Subject: License SUB-1010; Docket No. 40-8027
Amendment Request for Raffinate Sludge Dewatering Project
Response to Request for Additional Information

Response to NRC Request for Additional Information Dated February 17, 2004

ENCLOSURE 1
Sequoyah Fuels Corporation
Amendment Request for Raffinate Sludge Dewatering
Request for Additional Information

SEQUOYAH FUELS CORPORATION	
Title: Bagging and Weighing Area	
PREPARED BY: SFC	Filename: SFC0104A
Reviewed by: br	Figure No.4
Date: 03/08/2004

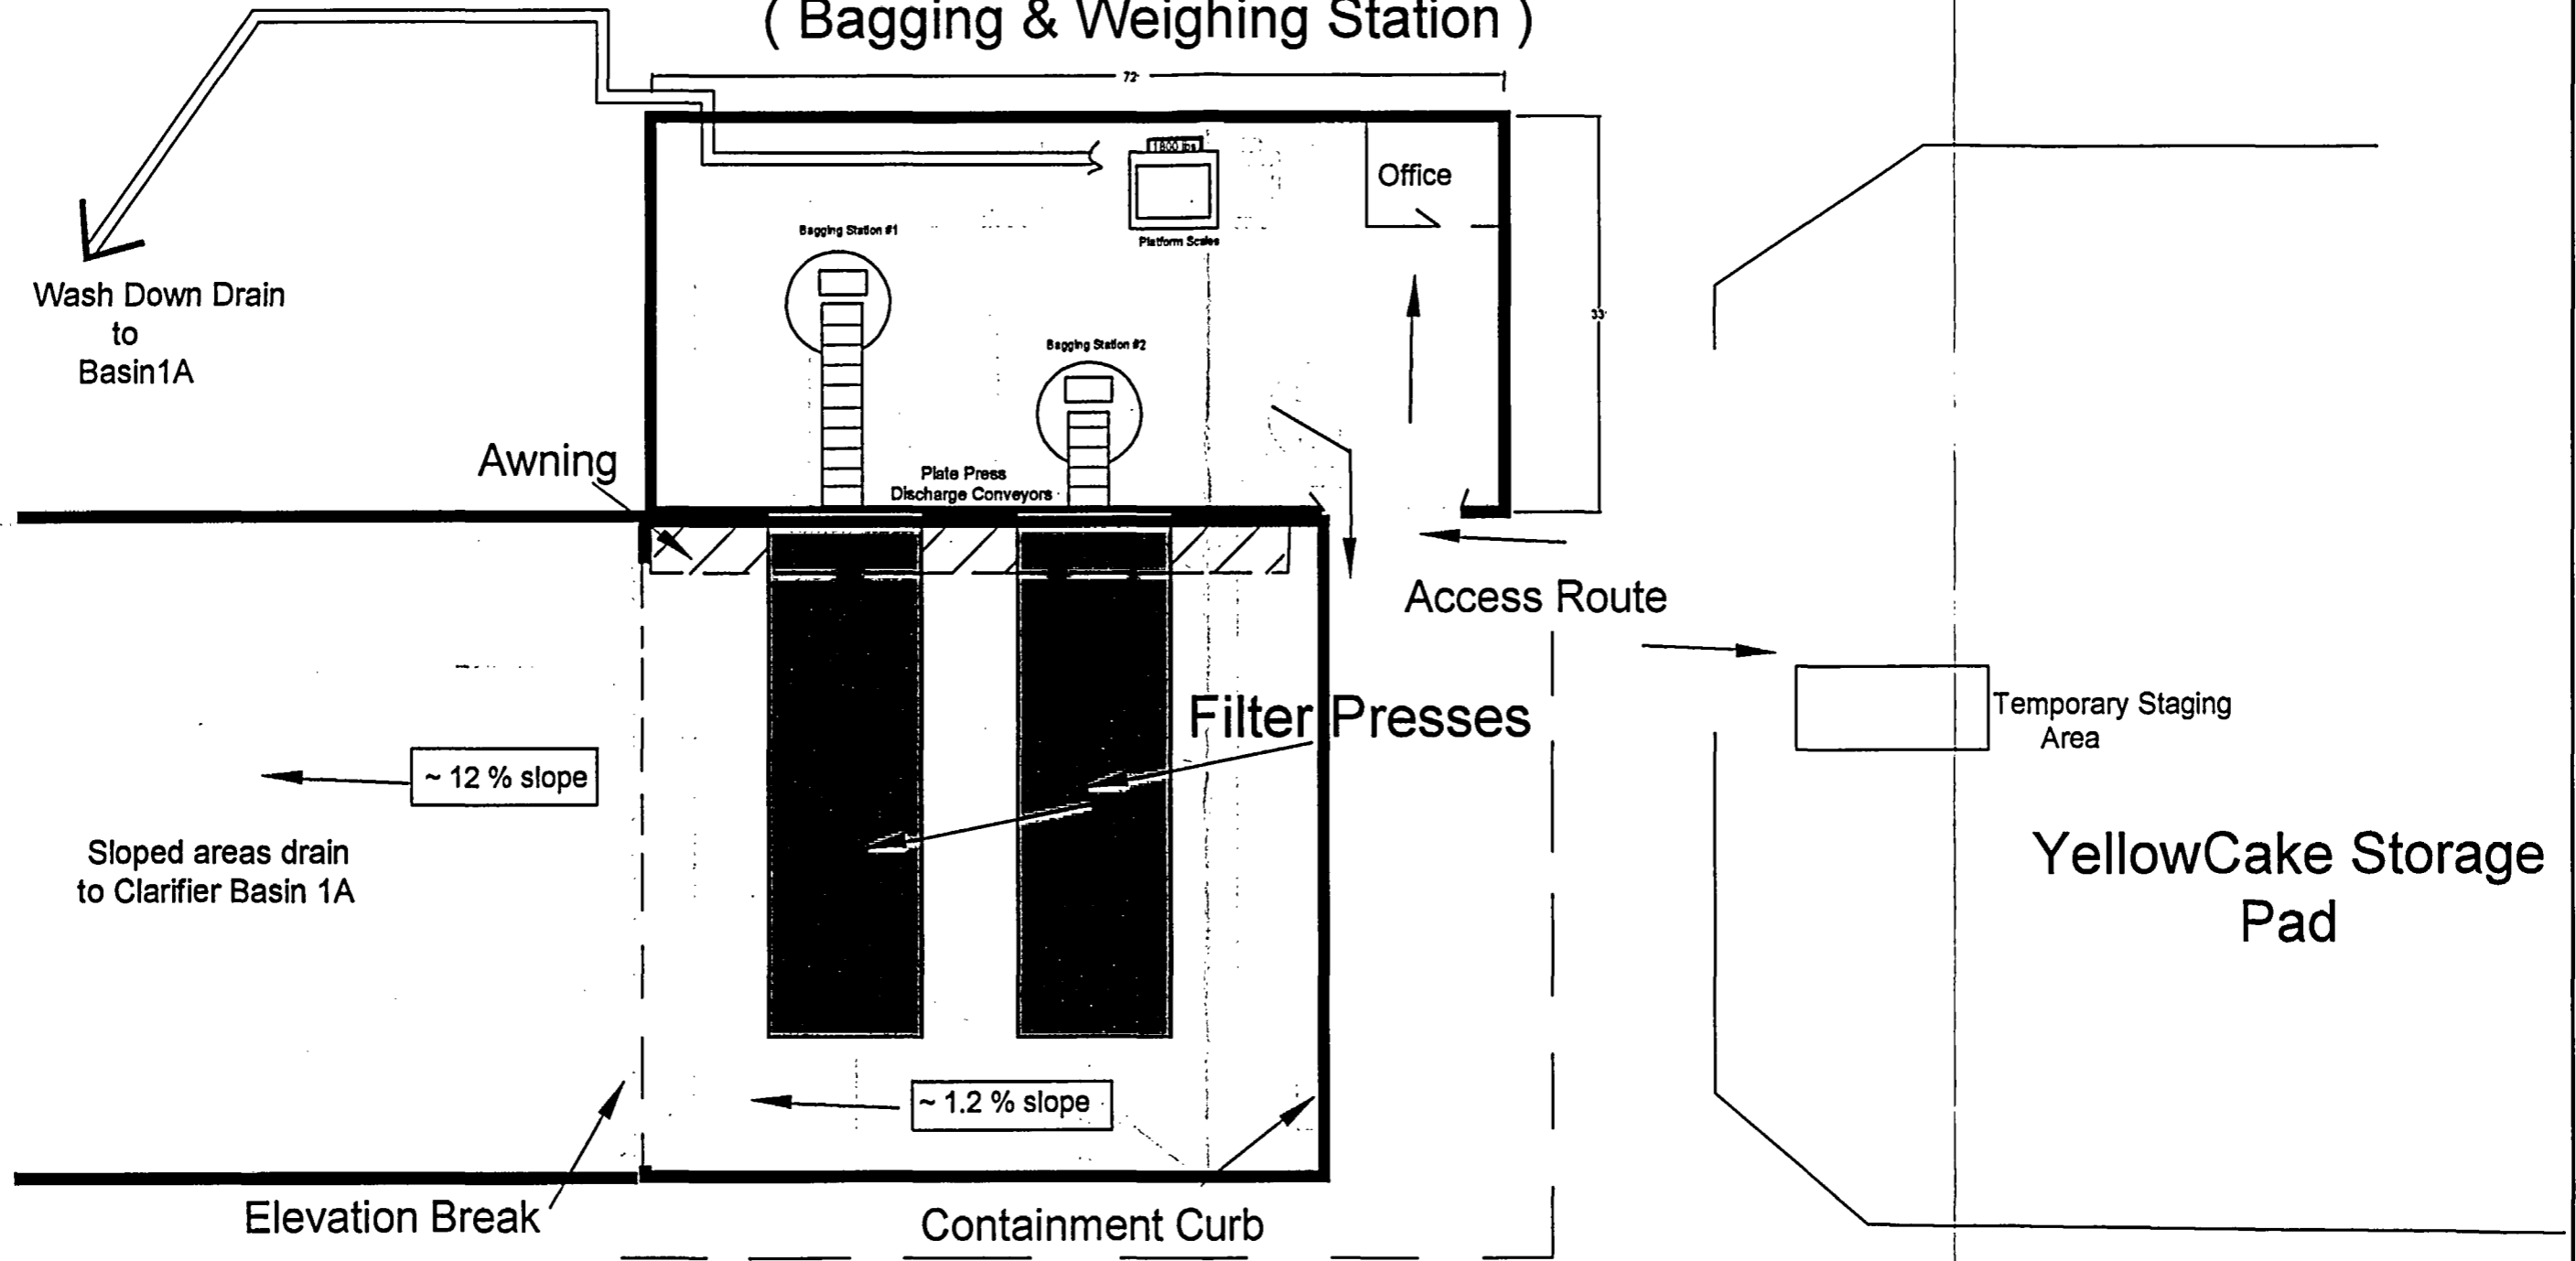
2. Please provide analysis, including but not limited to the following, to show how the design rainfall event will be accommodated:
 - a. Please provide design details regarding the sizing of sumps and pipes used to re-direct runoff, overflow and spills. Also, provide details or discussion of the adequacy of the height or cross-section of curbs and gutters (e.g. the north yellowcake drain) used to contain and redirect run-off.

Runoff will be redirected in the area of the Processing Pad and the Feed Tank area. The asphalt Processing Pad will have a slope of approximately 1.2% from east to west. From the west edge of the Processing Pad the grade will be sloped at approximately 12% to the Clarifier Basin. This will allow runoff from precipitation and wash down to drain directly to Clarifier Basin 1A.

The north end of the processing pad will be sealed against the Laundry Building (which will be used as the bagging and weighing station), and the south edge will be an existing concrete berm that will be approximately 6 inches above the asphalt pad.

Berms will be installed along the east side after the filter press trailers are in place, and will be made of either asphalt or railroad ties, and will be approximately 6 inches high. If railroad ties are used, they will be covered with HDPE and sealed against the asphalt pad. The berms will be installed after the filter press trailers are put in place.

The west side of the Processing Pad will not contain a berm. This area will be sloped from the Processing Pad to Clarifier 1A Basin such that rain water runoff as well as wash down water will drain directly to the basin. Details of this configuration are shown in revised Figure 4, attached.

Since there is no berm on the west side of the Processing Pad, the slope of the Processing Pad and graded area between the Processing Pad and Clarifier Basin 1A will provide adequate drainage for the Processing Pad Area.
